ADDENDUM NO. 1

Date: **February 27, 2023**
Issued by: **Sacramento City Unified School District**
Project: **Project #0363-409 Theodore Judah ES Paving Repairs**

SHEET TITLE	
UTILITY DETAILS	
JOB NUMBER:	SHEET NUMBER:
DATE: NOV 8, 2022	ADD1 C7.2
REVISION:

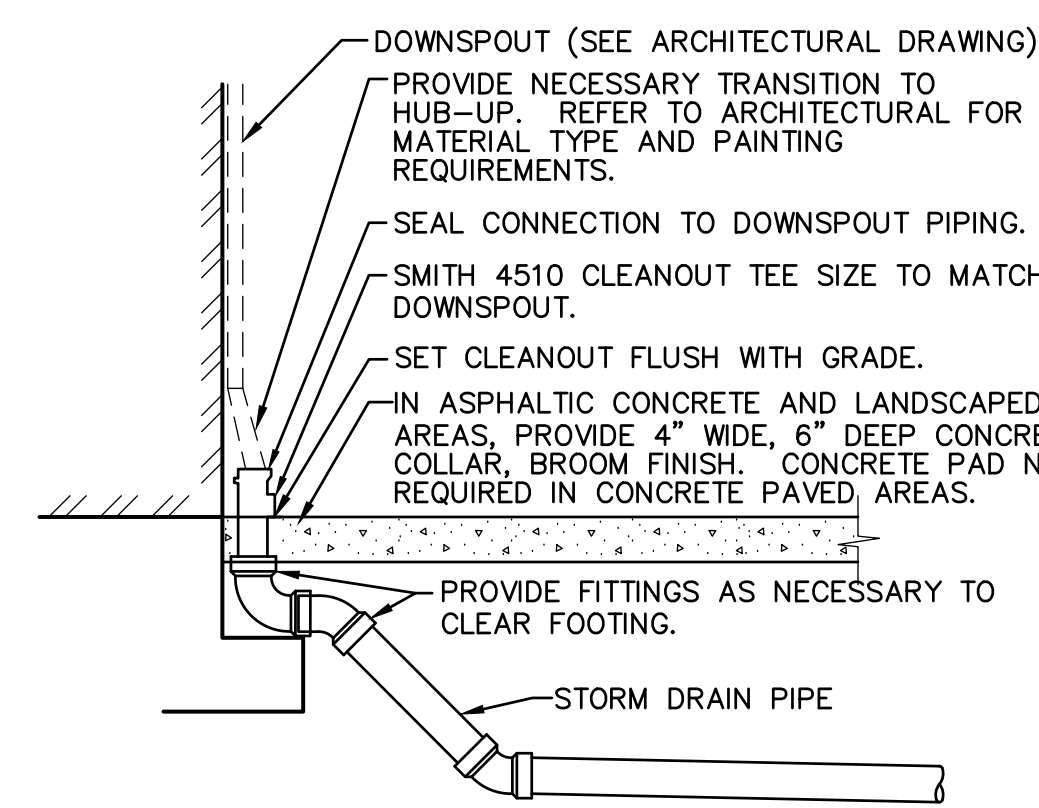
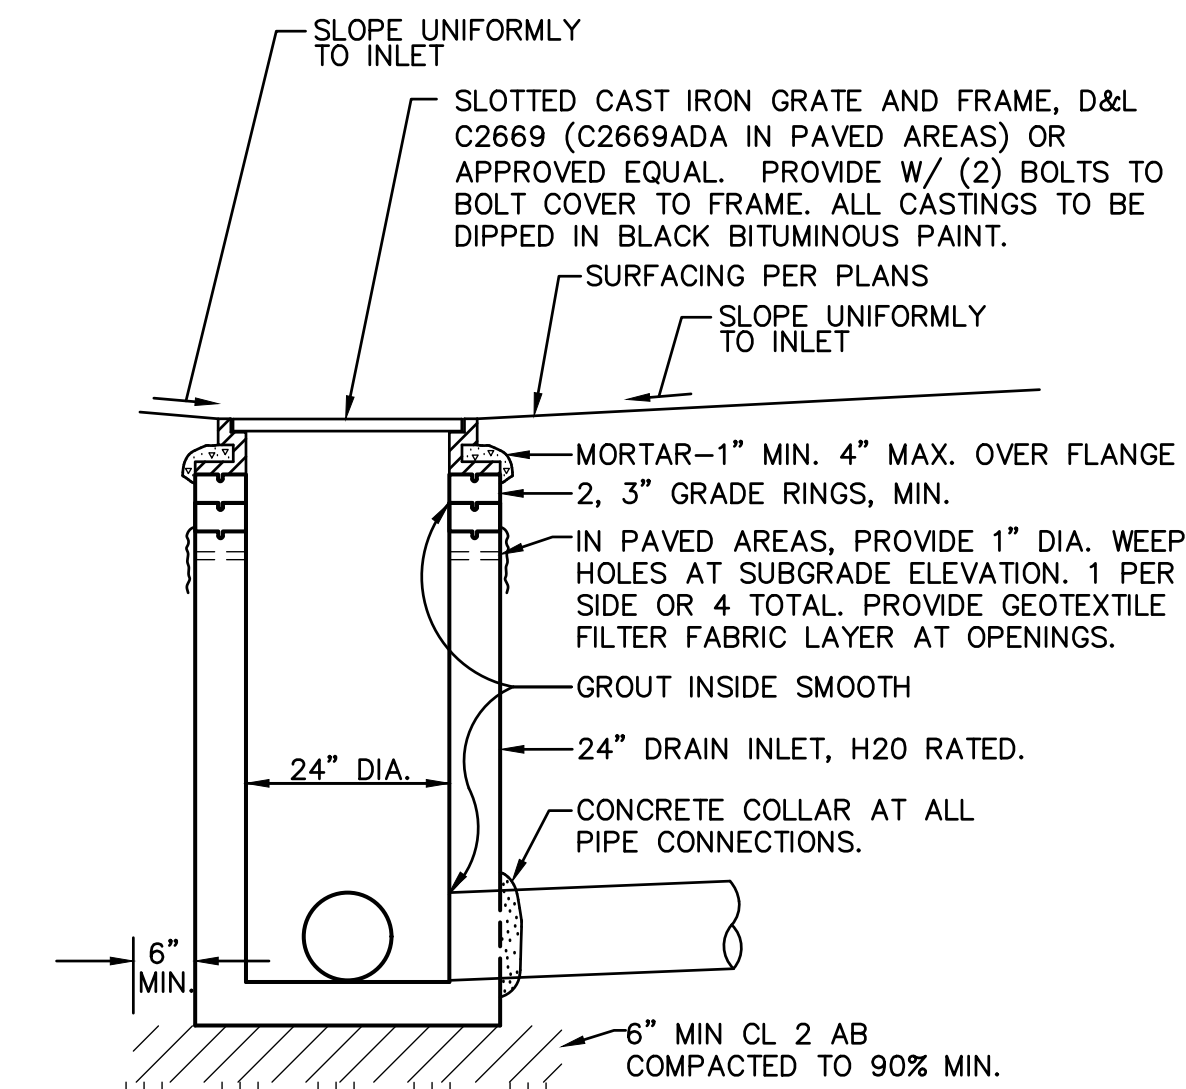
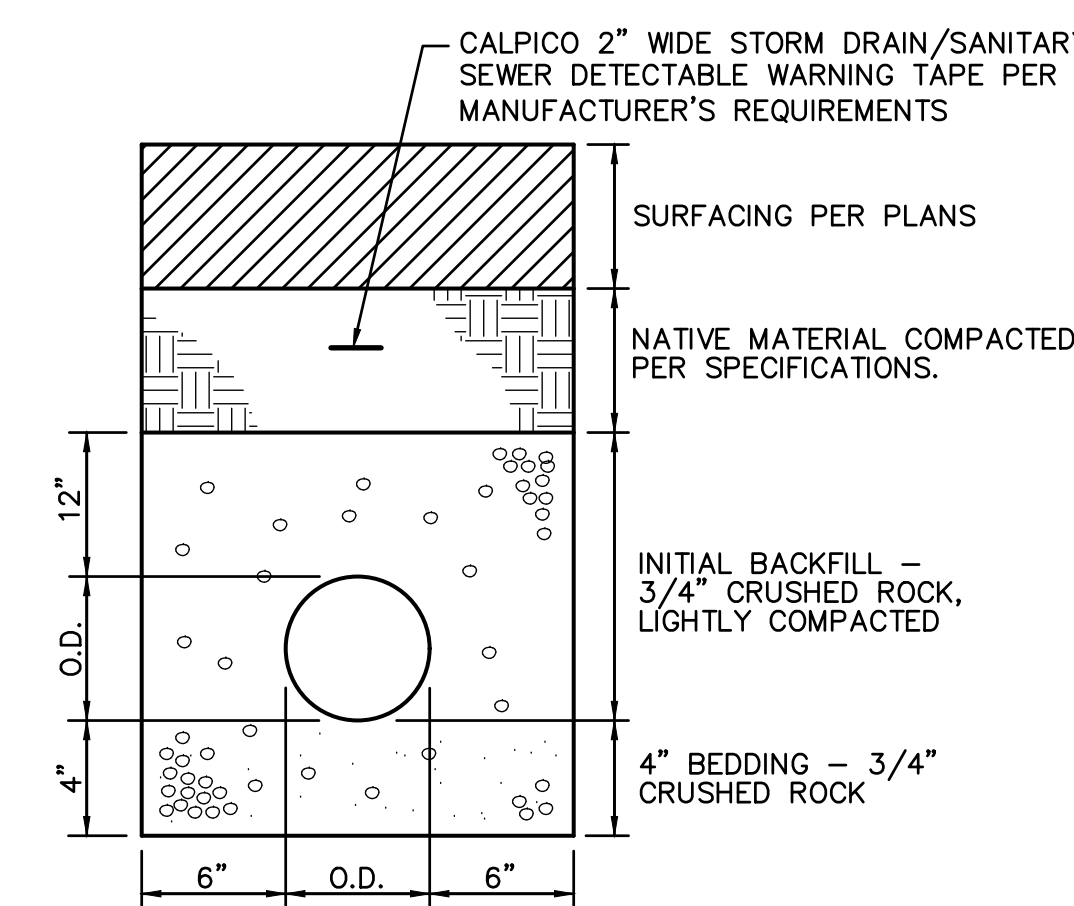
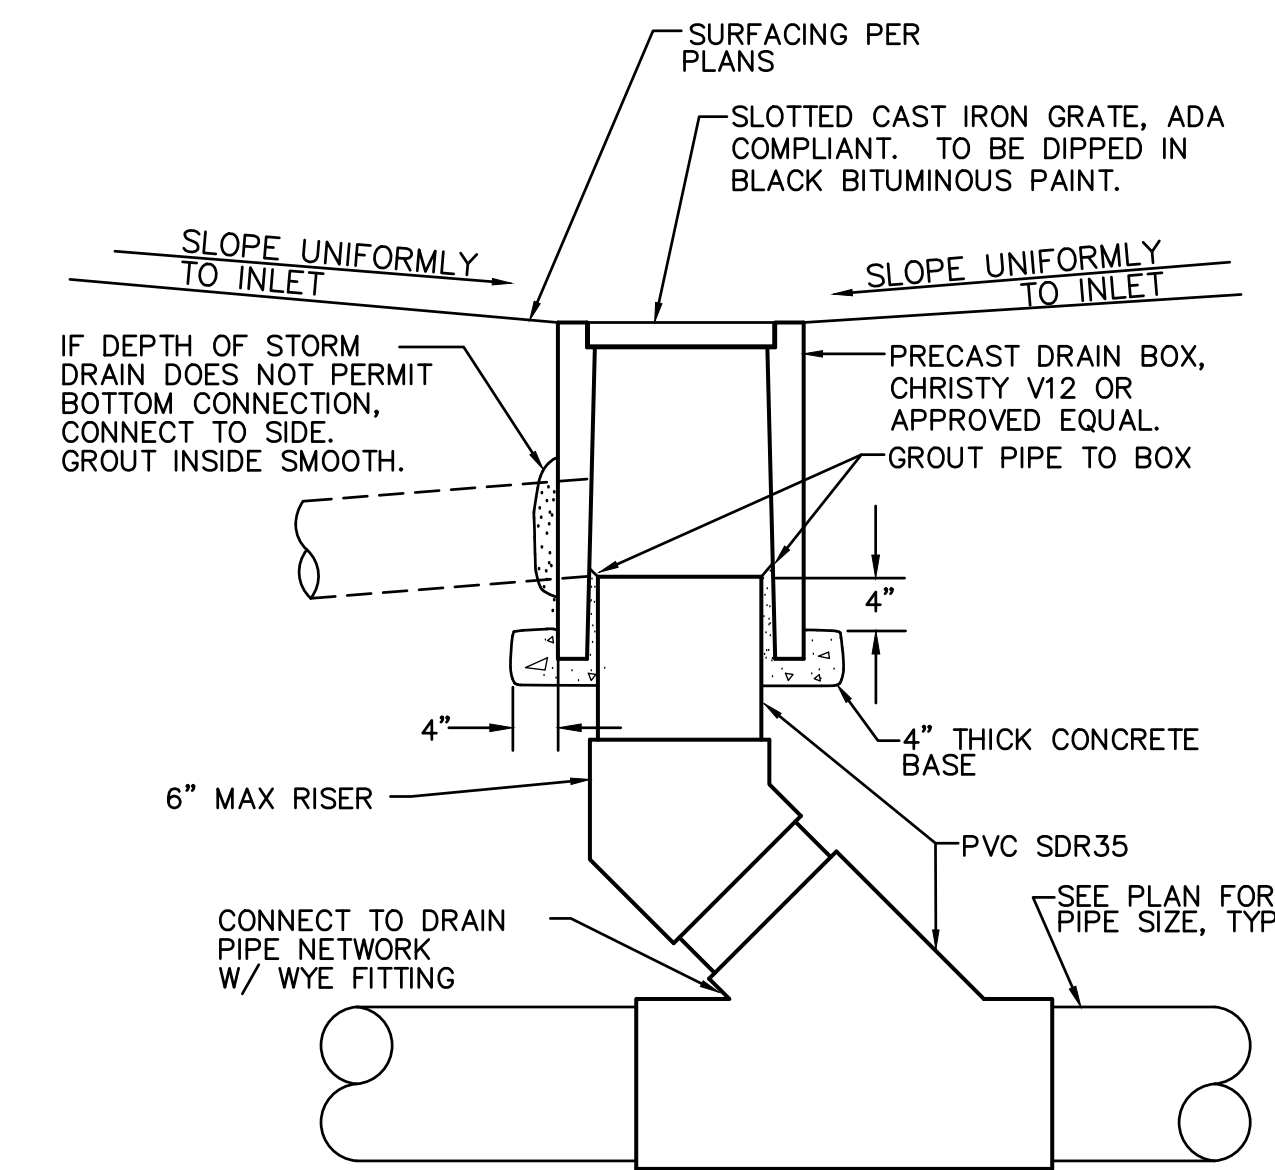
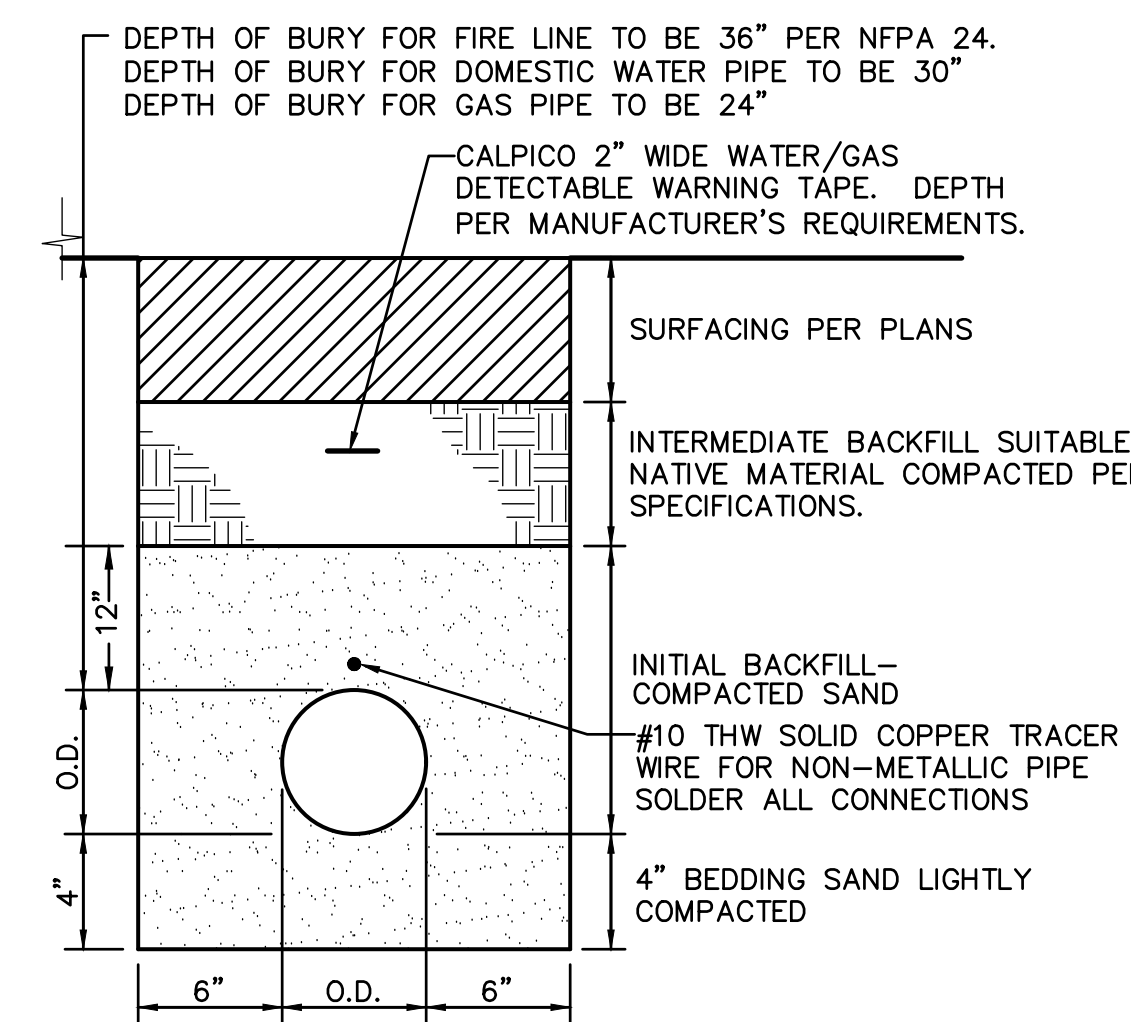
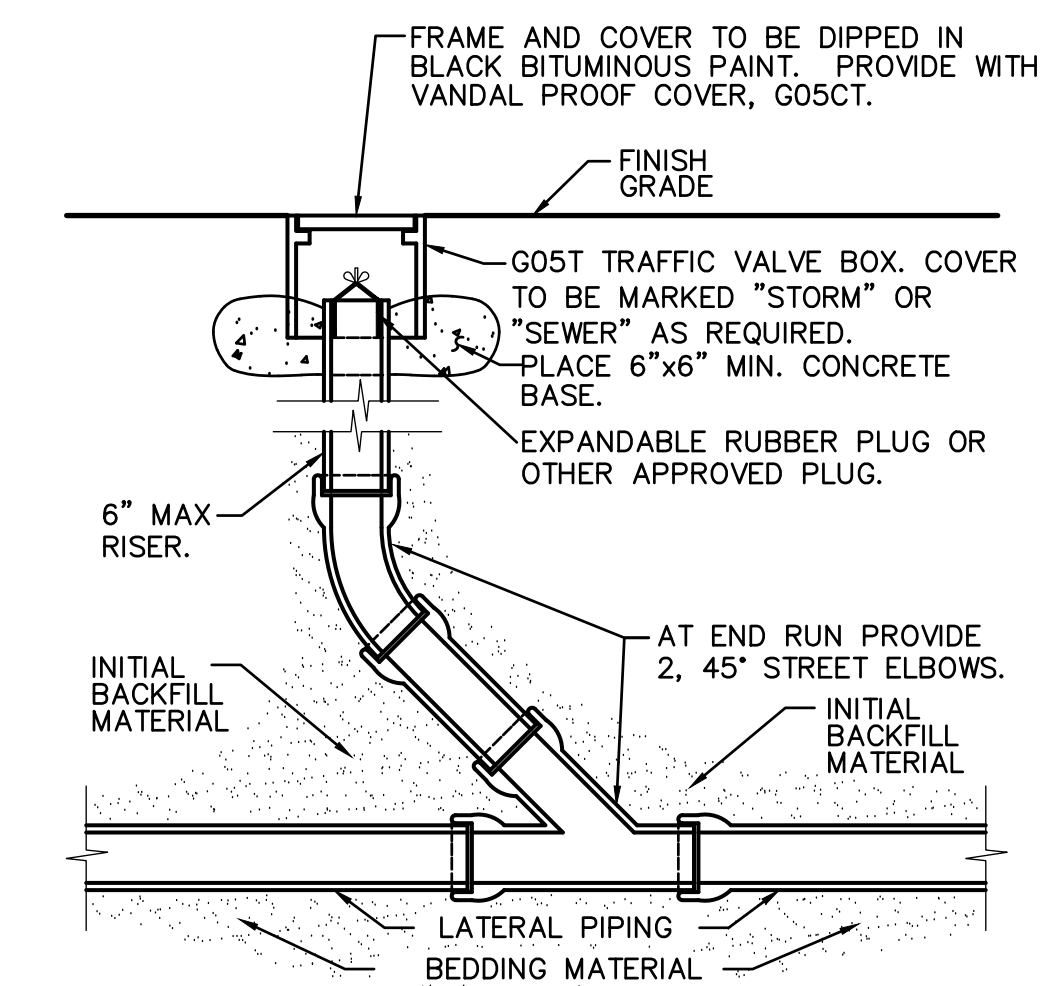
- AD01.14 Sheet C5.1 – Striping Plan: **Replace with the attached ADD1 C5.1.** The striping layout has been revised.
- AD01.15 Sheet C7.2 – Utility Details: **Replace with the attached ADD1 C7.2.** This sheet contains Utility Details that should have been part of the bid set.

Q6: Sheet C3.1 references a utility details sheet (C7.2) this drawing appears to be missing or sheet C7.1 has been duplicated. Please provide the utility details drawing.

Q15: Please provide the trench detail for the underground utilities.

Q22: On plan sheet C3.1, several notes reference details related to the underground utilities on plan sheet C7.2. However, sheet C7.2 does not have any utility details. Please provide these missing details.

A6: Sheet C7.2 is included with this addendum.

A15: Trench sections are detailed on Sheet C7.2, included with this addendum.

A22: The correct Sheet C7.2 is included with this addendum.

11 WALL BALL COURT NO SCALE

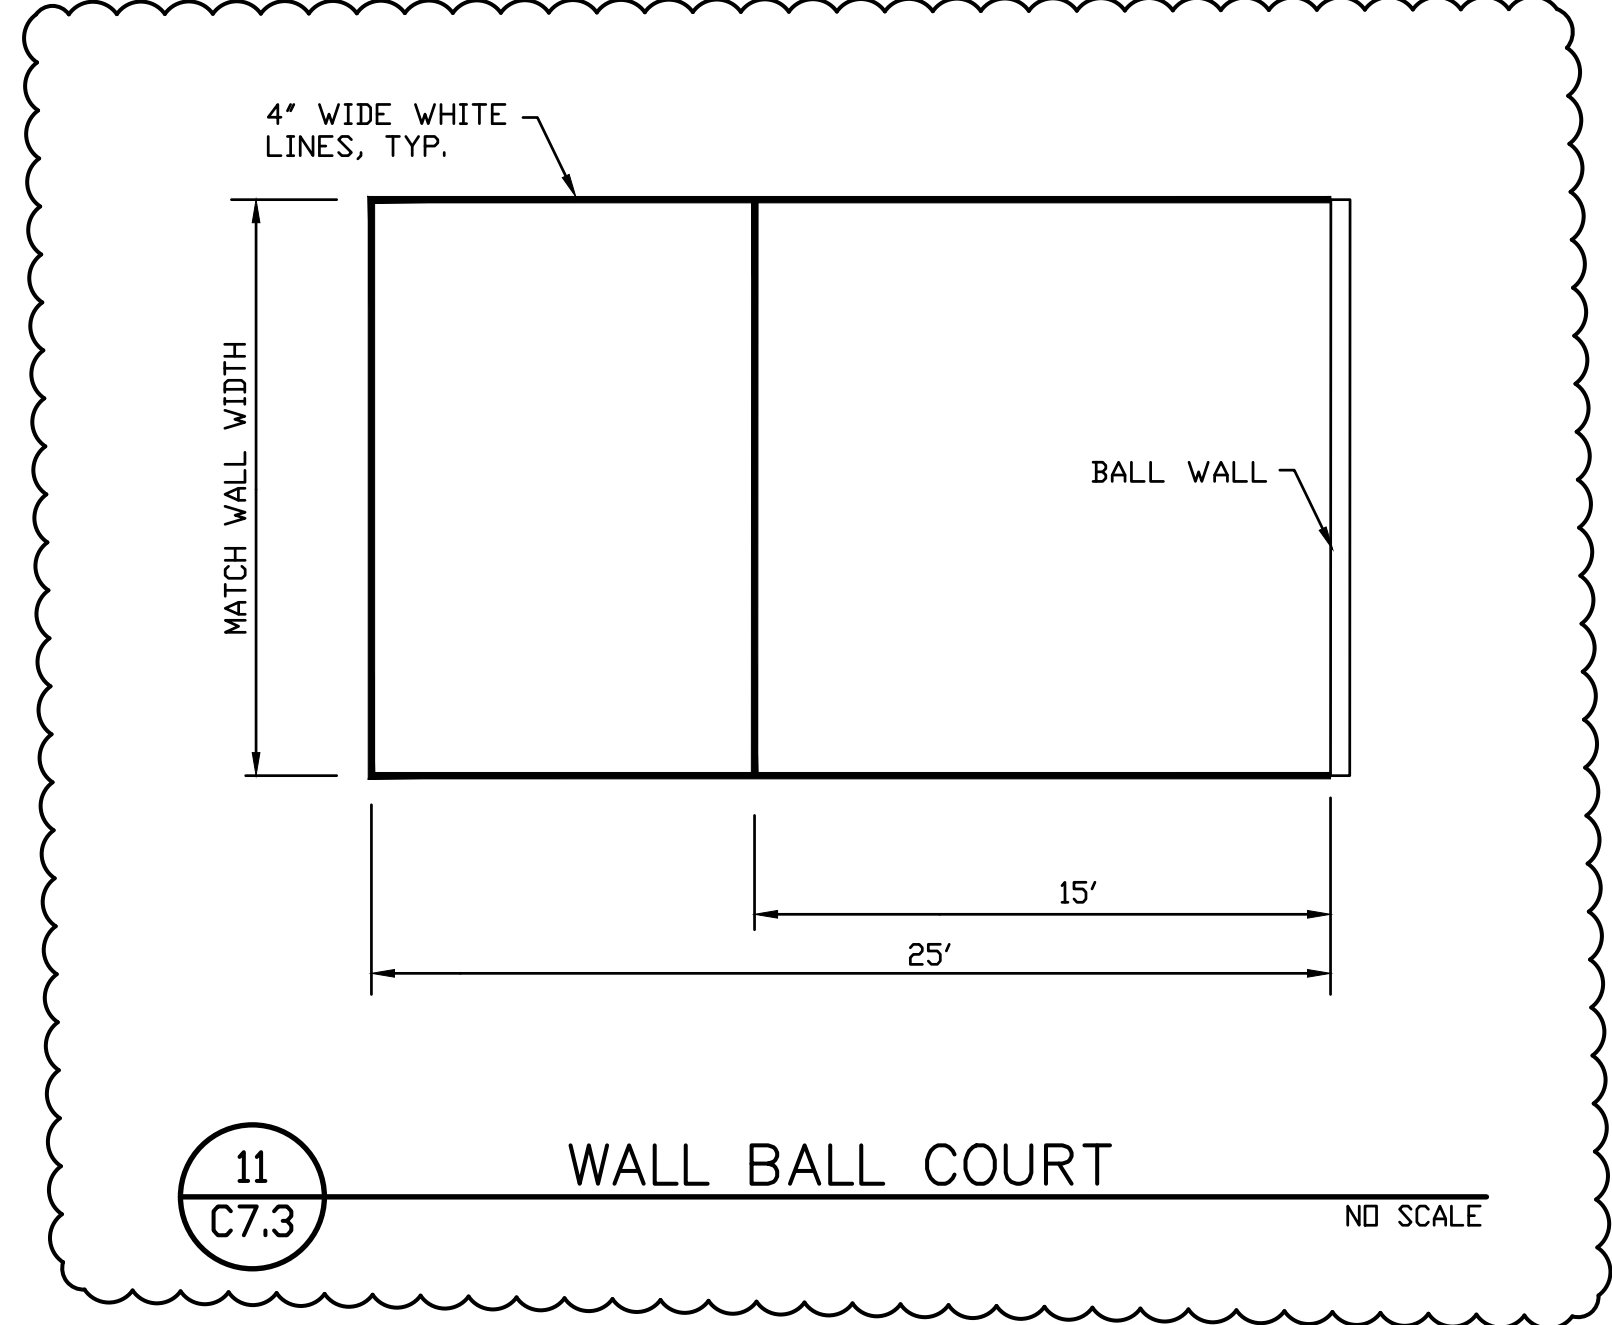
- AD01.16 Sheet C7.3 – Striping Details: **Replace with the attached ADD1 C7.3.** Removed Details 11 & 12 volleyball court and pole and 13 Squares Court Detail. Added new Detail 11 Ball Wall Court.
